JPB CAC
CORRESPONDENCE
AS OF
June 17, 2025

From: [Roland Lebrun](#)
To: [Public Comment](#)
Cc: [Board \(@caltrain.com\)](#); [cacsecretary \[@caltrain.com\]](#); [SFCTA CAC](#)
Subject: Board Board Budget Workshop item 5 Public Comment
Date: Wednesday, May 28, 2025 4:18:28 PM
Attachments: [Business case for 4-car EMU trainsets.pdf](#)
[Business case for Battery-electric locomotives.pdf](#)

From: [Roland Lebrun](#)
To: [Public Comment](#)
Cc: [Board \(@caltrain.com\)](#); [cassecretary \(@caltrain.com\)](#); [SFCTA CAC](#)
Subject: Item 9 Guadalupe River Bridge Replacement
Date: Wednesday, June 4, 2025 2:58:00 AM
Attachments: [image.png](#)
[image.png](#)
[Guadalupe River Bridge alternative proposal.pdf](#)
[Drawing TT-D4004.pdf](#)

From: [Roland Lebrun](#)
To: City.clerk@sanjoseca.gov
Cc: [Board \(@caltrain.com\)](#); [cacsecretary \(@caltrain.com\)](#); [Caltrain, Bac \(@caltrain.com\)](#)
Subject: City Council Item 2.27 At-Grade Station Alternative and Diridon Program
Date: Tuesday, June 10, 2025 4:06:15 AM
Attachments: [Item 2.27 Diridon City Council June 10 2025.pdf](#)

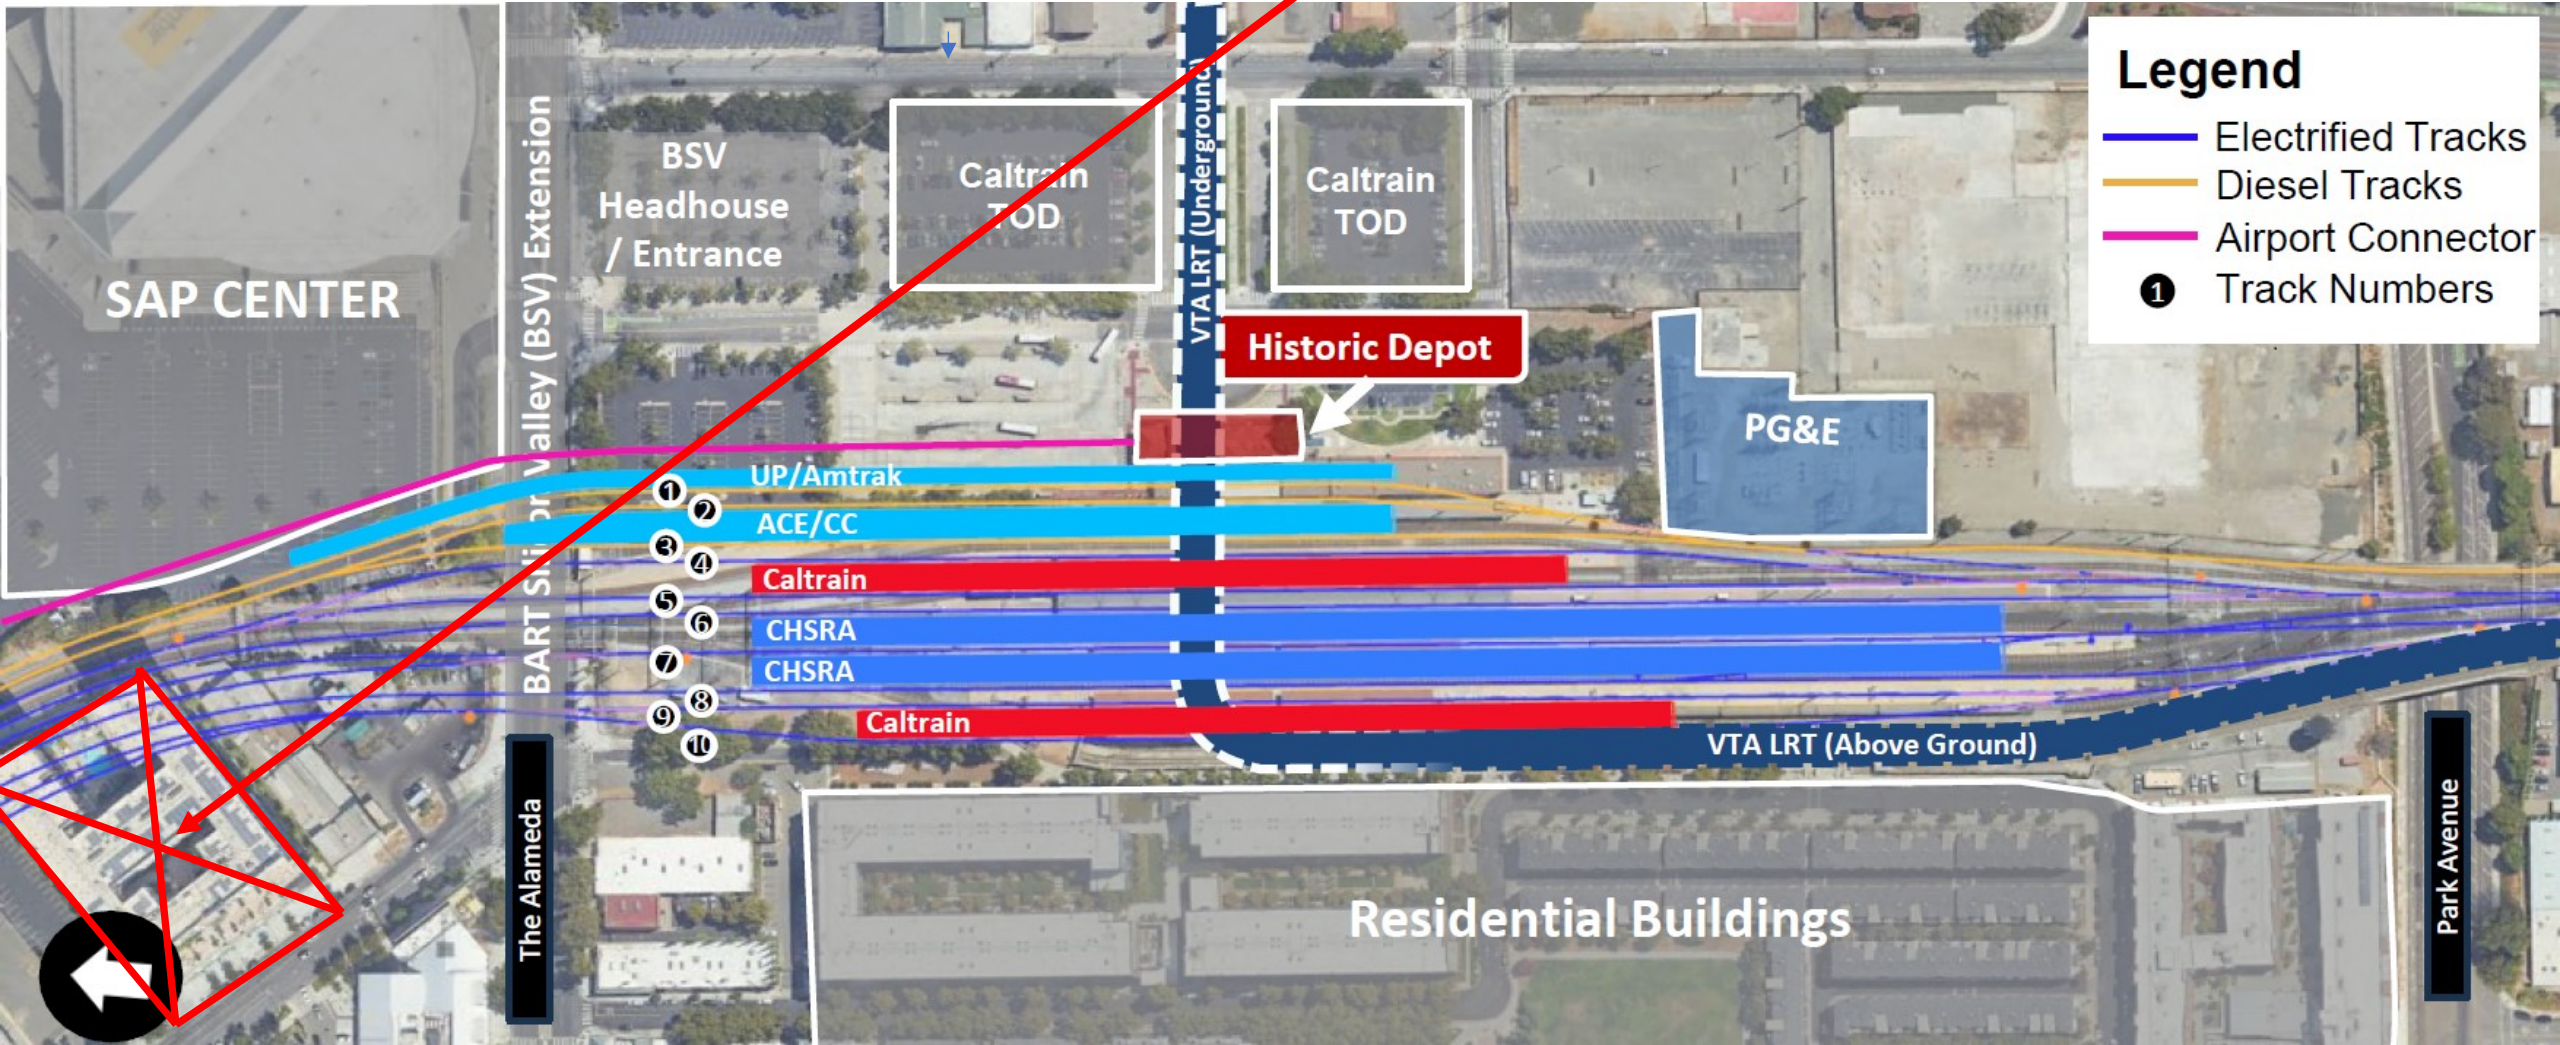
Shifting the station platforms one block too far north resulted in impacts on the Vespaio Apartment complex

The lack of grade-separation between vehicular traffic, bikes and peds introduces multiple Vision Zero conflicts

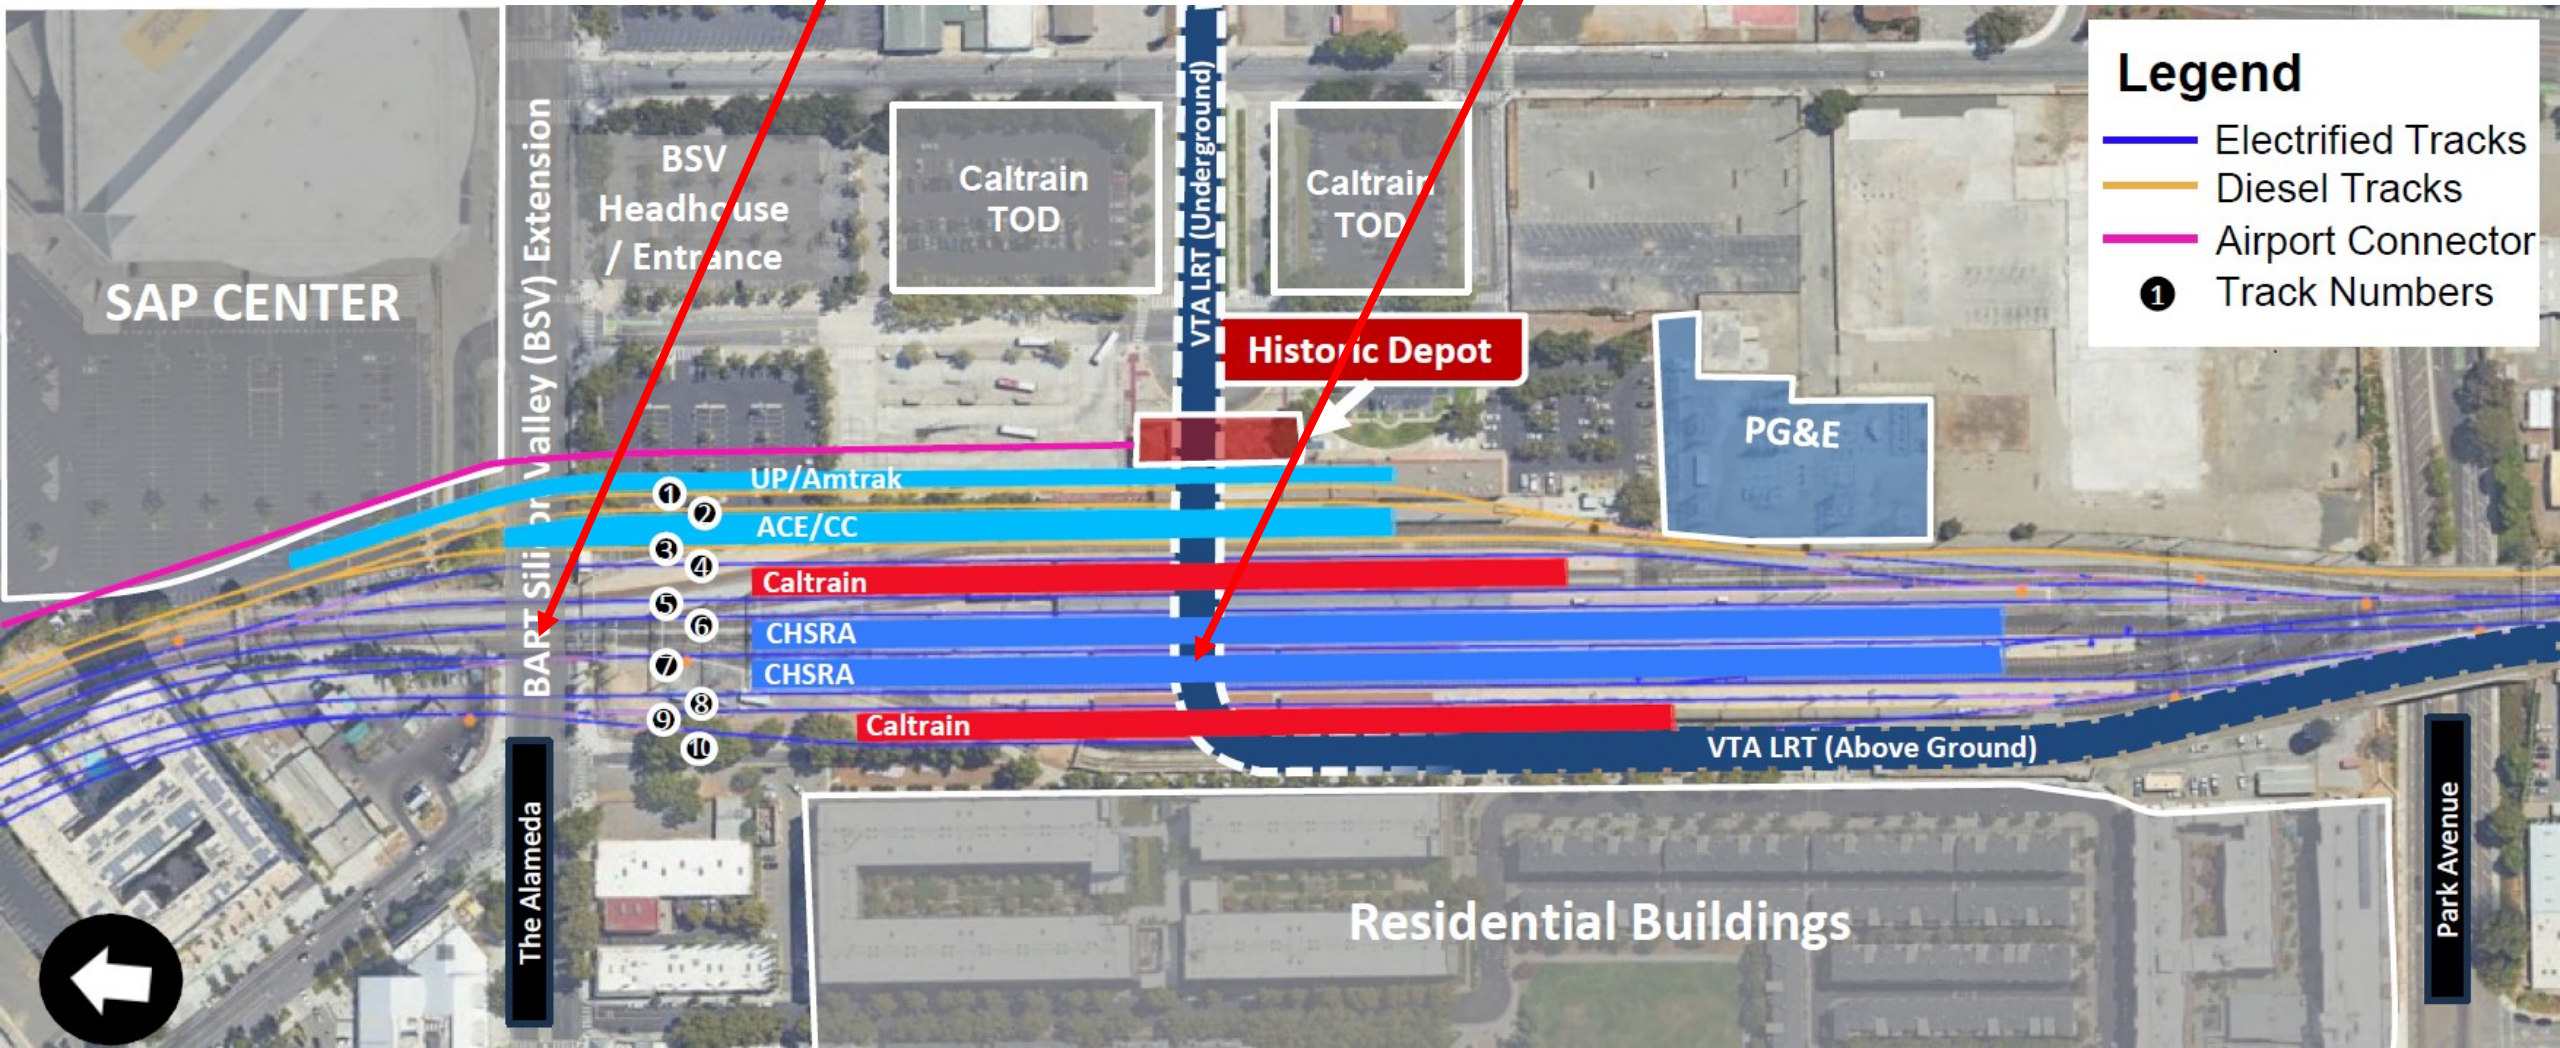
There is no integration between
BART and the light rail

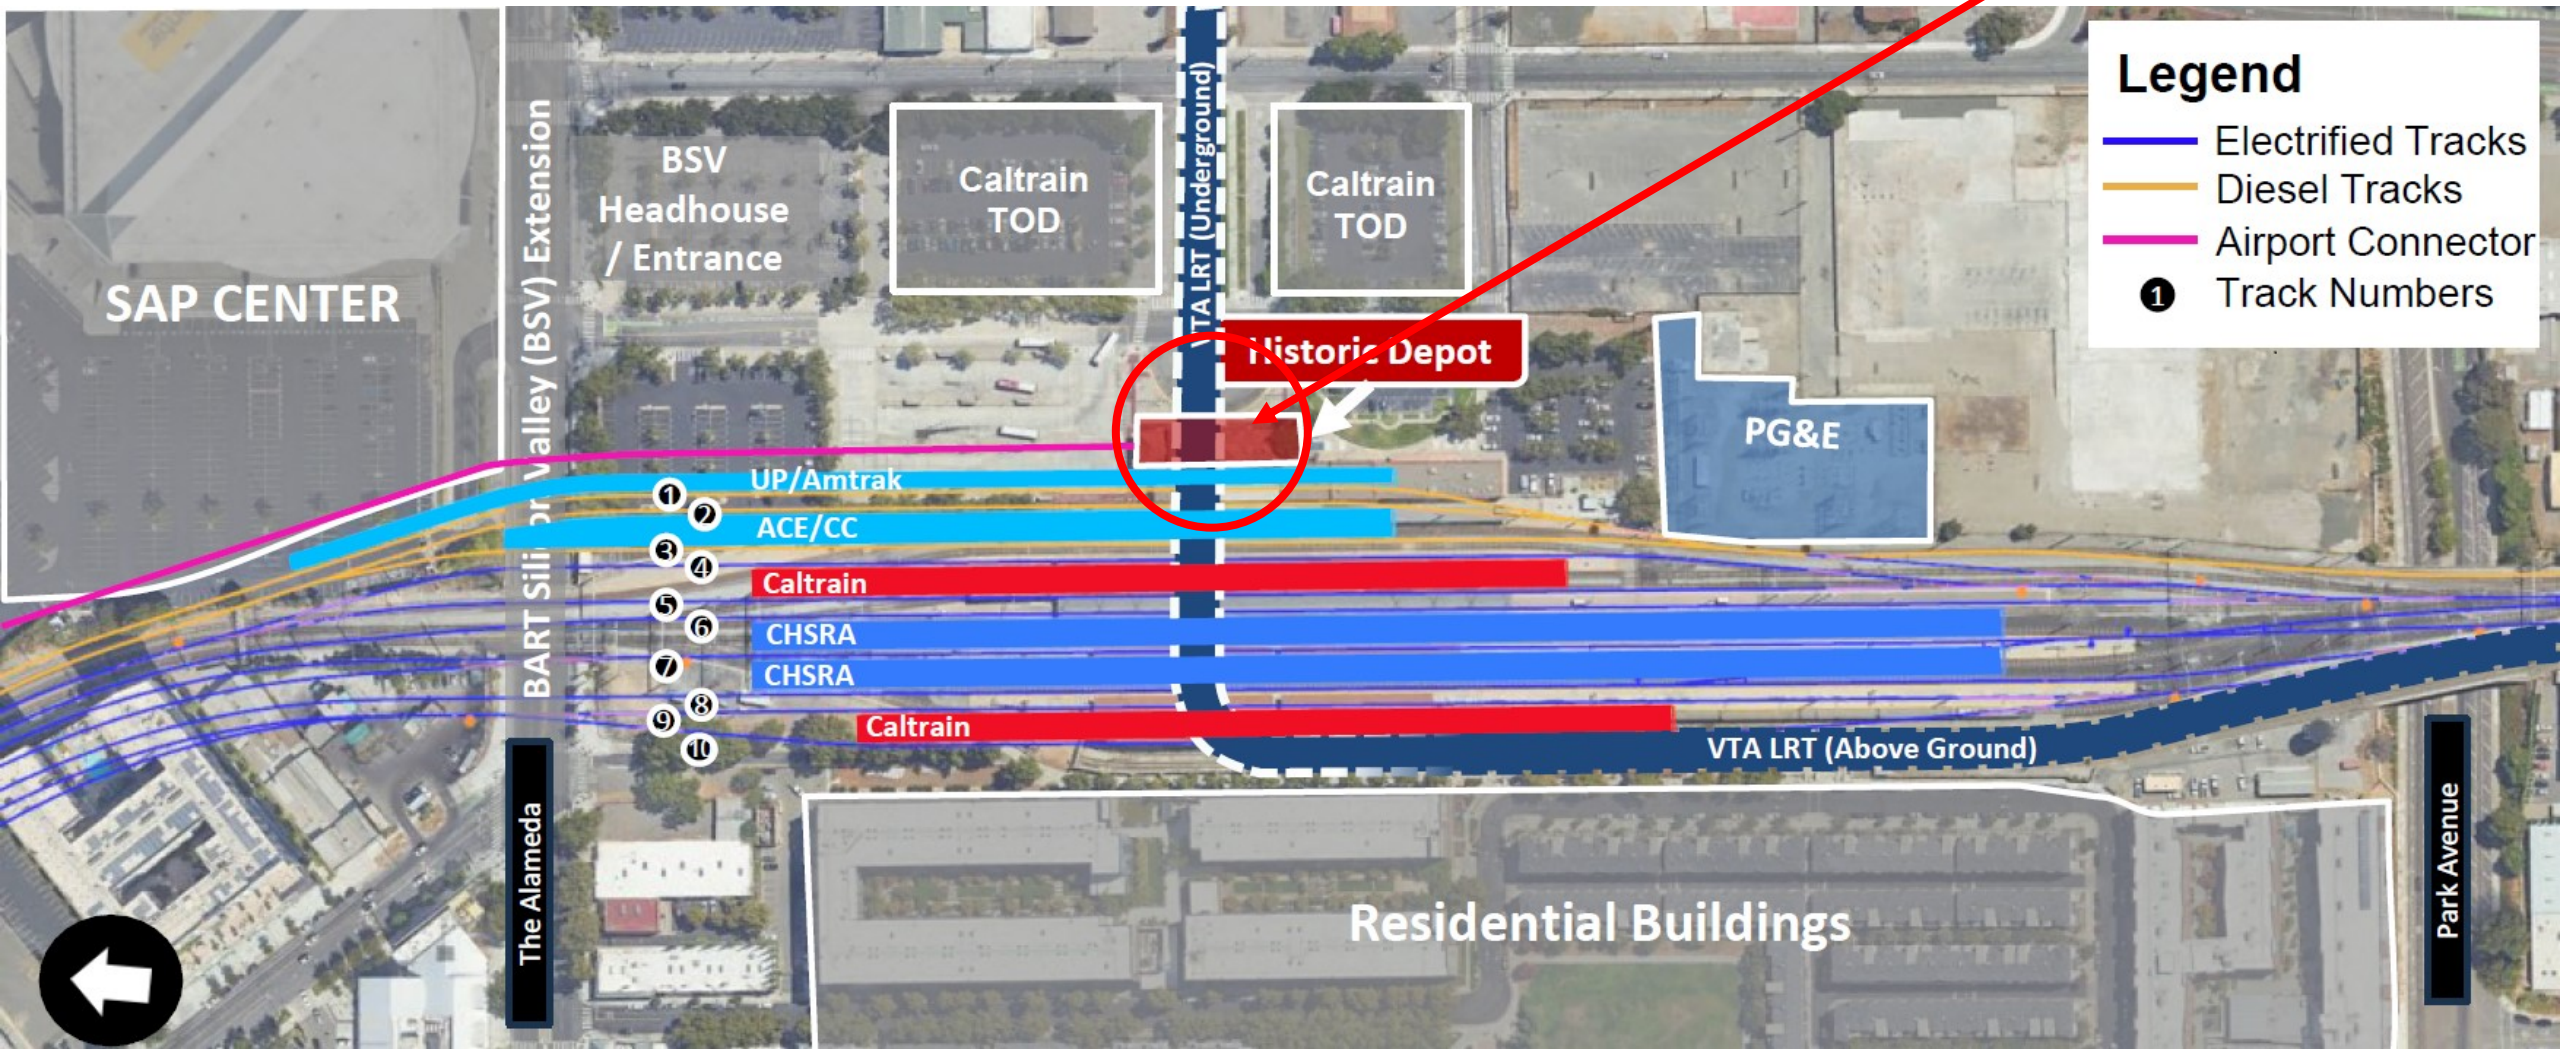
The light rail realignment bisects Downtown West (conflicts with EIR) and conflicts with the Historic Depot

The light rail tunnel realignment requires a complete demolition and reconstruction of the historic depot

The iconic gateway to Downtown San Jose is missing
